Addendum No. 1

Re: **Barrett Station Veterinarian Clinic**
13840-13844 Manchester Road
Ballwin, Missouri 63011

Drawing Issue: Bid & Permit Set Addendum #1

1 FLOOR PLAN
A1 | A1 SCALE: 3/16" = 1'-0" NORTH

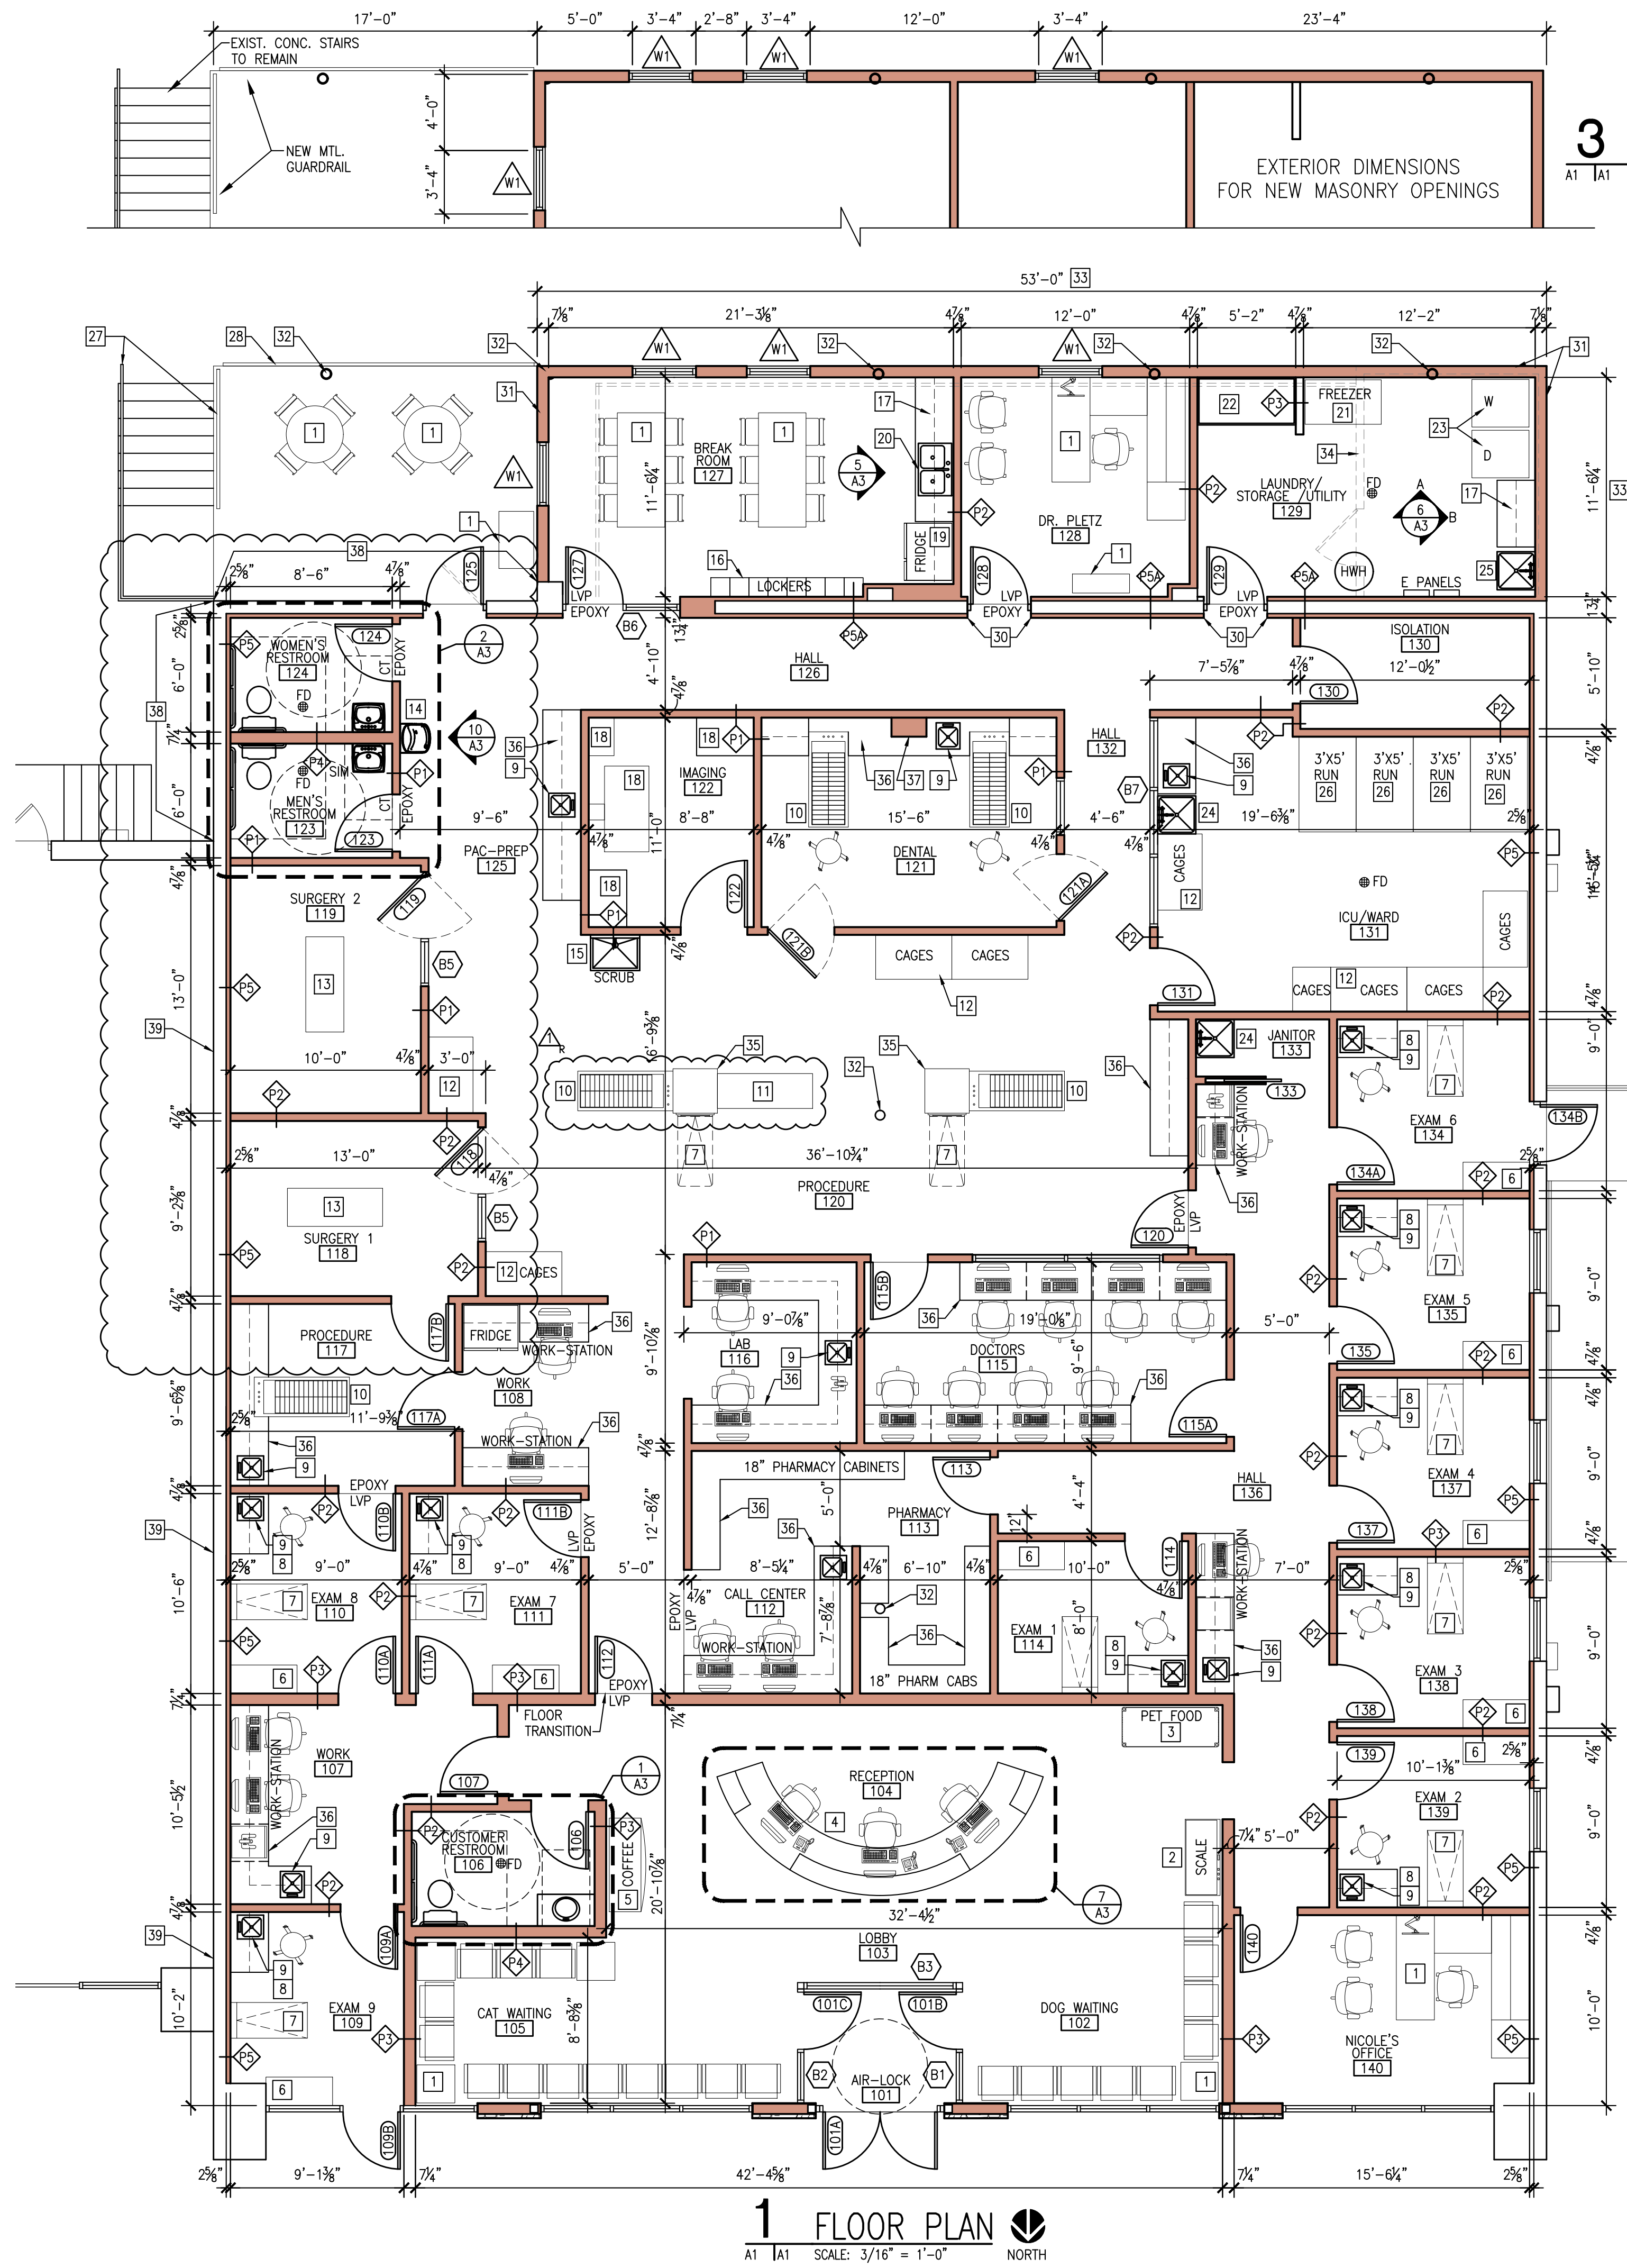
1. Sheet A1, Floor Plan, Notes & Details.
 - a. Added Keyed Note 38 to paint existing exposed walls at the Southwest side and rear wall.
 - b. Added Keyed Note 39 to describe the existing partition wall is a 1-hr CMU block wall.
 - c. Added Demolition General Notes.
 - d. Deleted the Cat Ward 118 and added a second Surgery Room 118.
 - e. Adjusted the Surgery Room 119 and the Restroom sizes accommodate the new Surgery Room 118.
 - f. Flipped the wet table in the Procedure Room 120 to the opposite (left) side of the tower.
2. Sheet A2, Reflected Ceiling Plan
 - a. Deleted the Cat Ward 118 and added a second Surgery Room 118.
 - b. Adjusted the Surgery Room 119 and the Restroom ceilings to accommodate the new Surgery Room 118.
 - c. Added "Paint Existing Structure" to the existing covered patio.

2 ENLARGED FLOOR PLAN
A3 | A1 SCALE: 1/4"=1'-0"

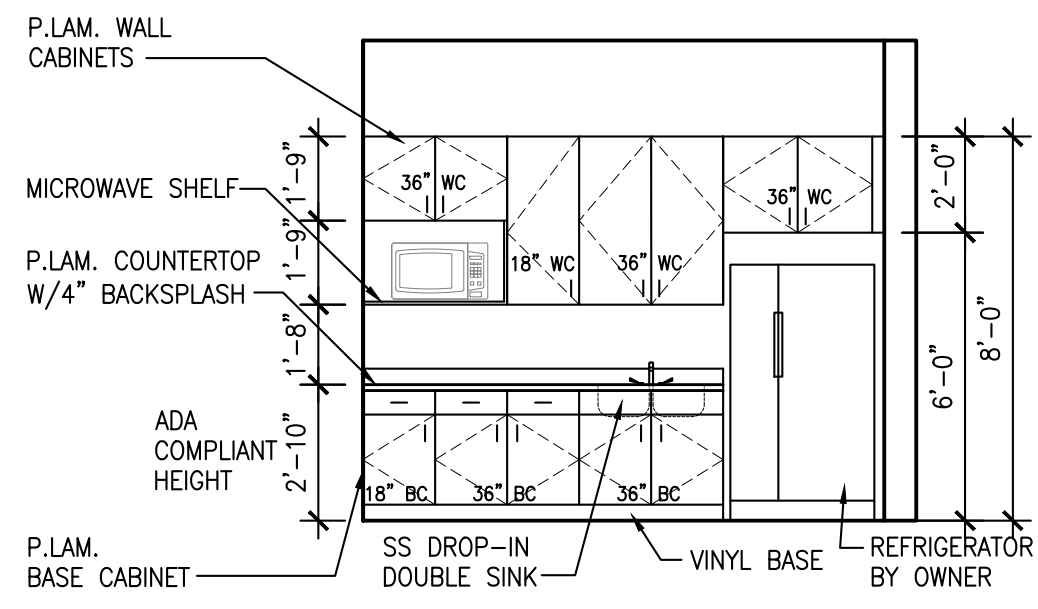
3. Sheet A3, Enlarged Floor Plans & Interior Elevations
 - a. #2 Enlarged Floor Plan, adjusted the Restroom sizes.
4. Sheet A4, Roof Plan & Notes – No revisions.

2 PARTIAL EAST ELEVATION

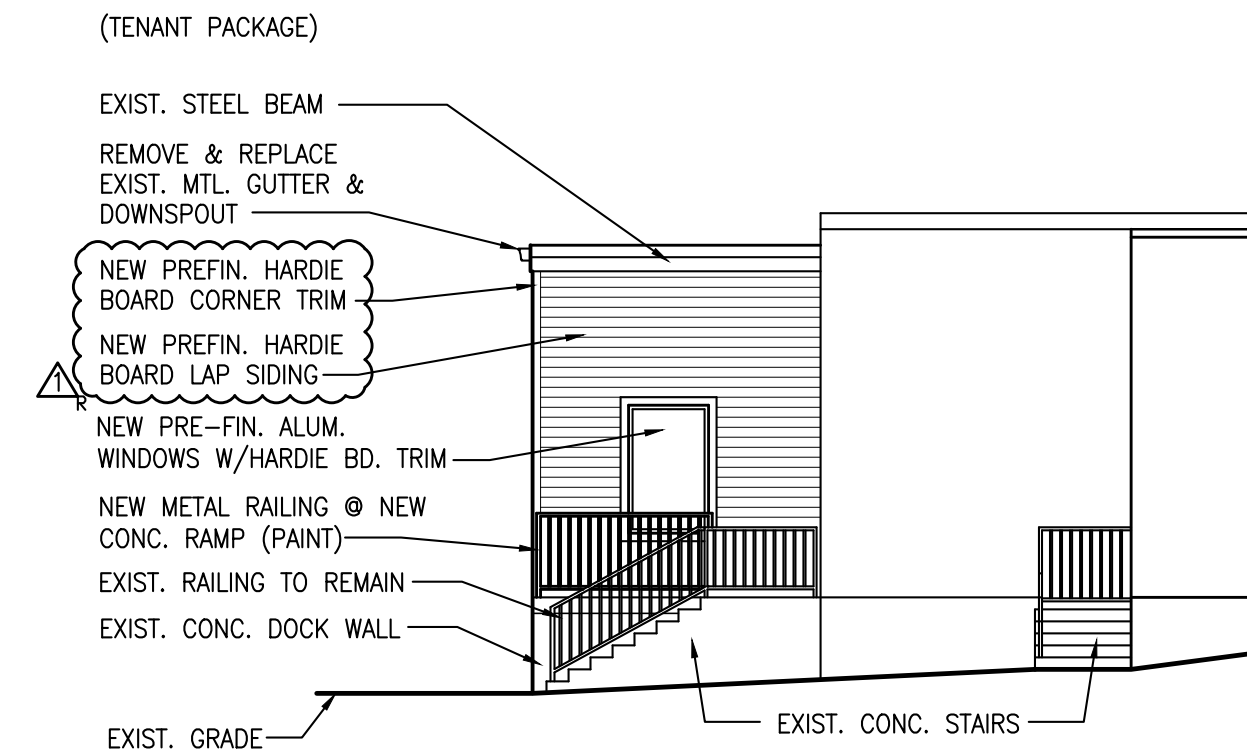
5. Sheet A5, Exterior Elevations and New Ramp
 - a. #2 Partial East Elevation, added “Prefinished” for the Hardie Siding.
 - b. #3 West Elevation, added “Prefinished” for the Hardie siding.

4 PARTIAL SOUTH ELEVATION

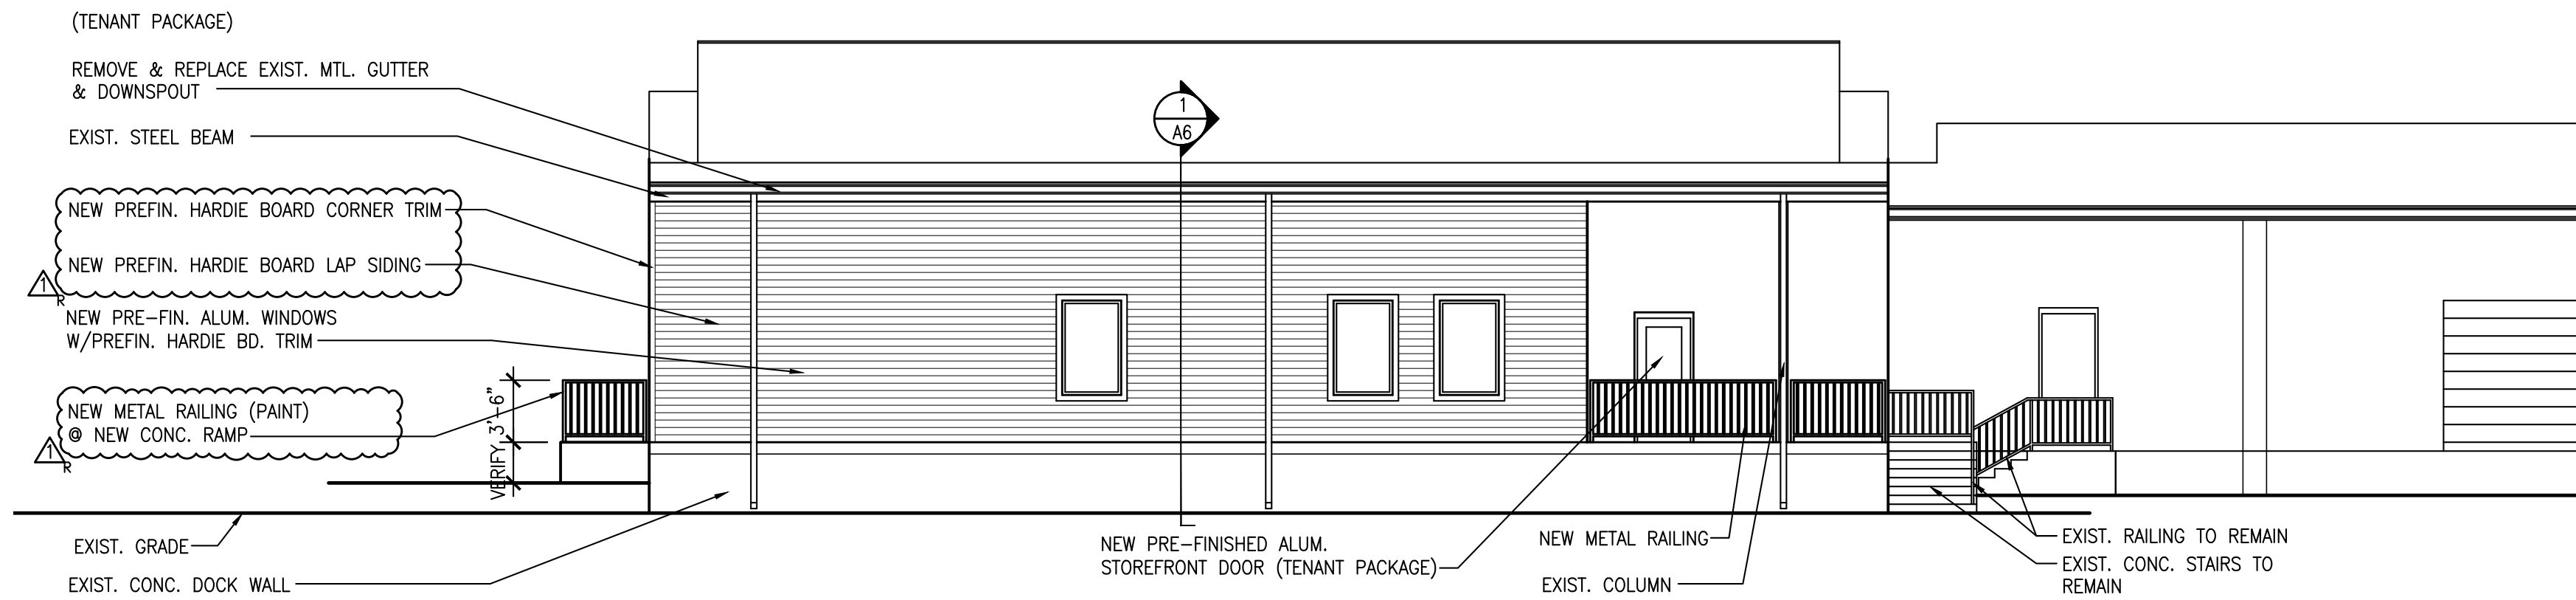
- c. #4 Partial South Elevation, added “Prefinished” for the Hardie siding
 - d. #4 Partial South Elevation, added “Paint” for metal railing.
 - e. #5 Ramp Section, added “Paint” for the metal guard rail and handrail.

2 MECHANICAL PLAN
SCALE: 3/16"=1'-0"

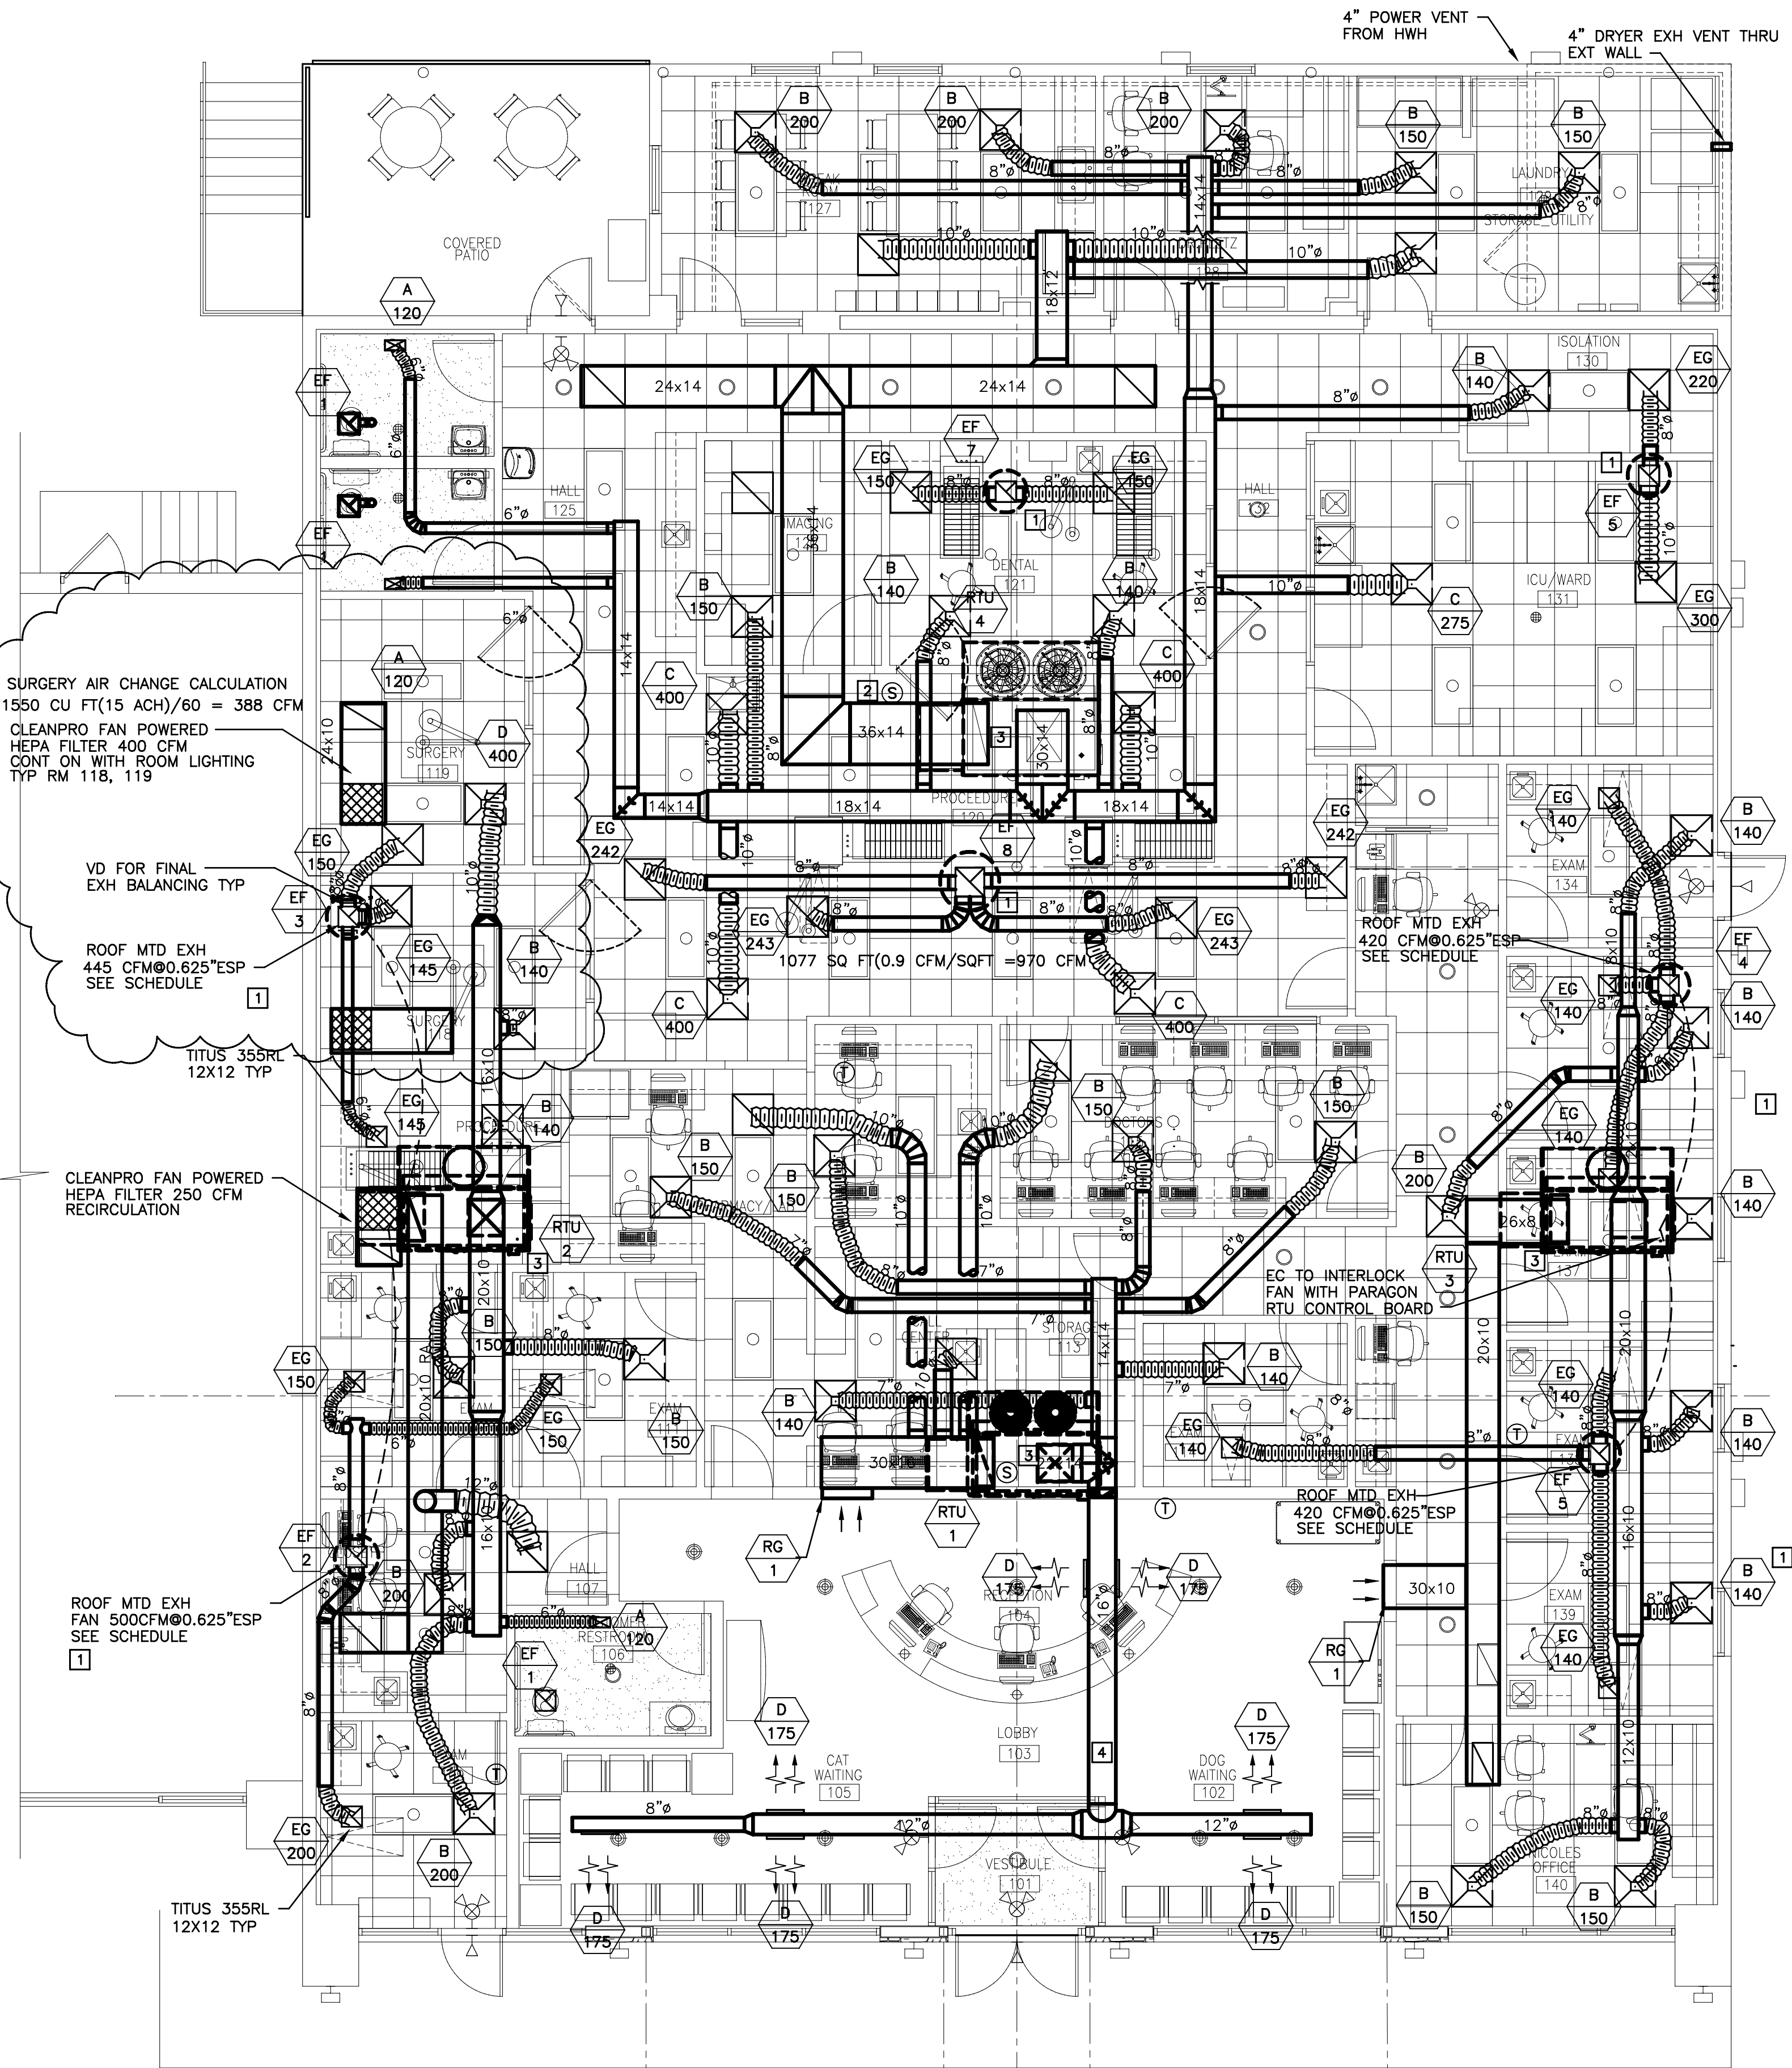
8. Sheets M-1, M-2 and M-3, Mechanical General Notes, Mechanical Plan and Schedules
 - a. Revised Mechanical Plan for the new Surgery Room.
9. Sheets E-1, E-2 and E-3, Electrical Specifications, Power Plan and Lighting Plan
 - a. Revised Power Plan for the new Surgery Room.
 - b. Added Panelboard Schedules.
 - c. Revised the Lighting Plan for the new Surgery Room.
10. Sheets P-1, P-2 and P-3, Plumbing General Notes, Sanitary Plumbing Plan and Piping Plan
 - a. Revised the Sanitary Plumbing Plan for the Restroom shift.
 - b. Revised the Plumbing Piping Plan for the Restroom shift.
 - c. Note the wet table on the left side of the Procedure Room should be “flipped” to the left side of the tower. Refer to the Architectural Floor Plan sheet A1 for the correct location.
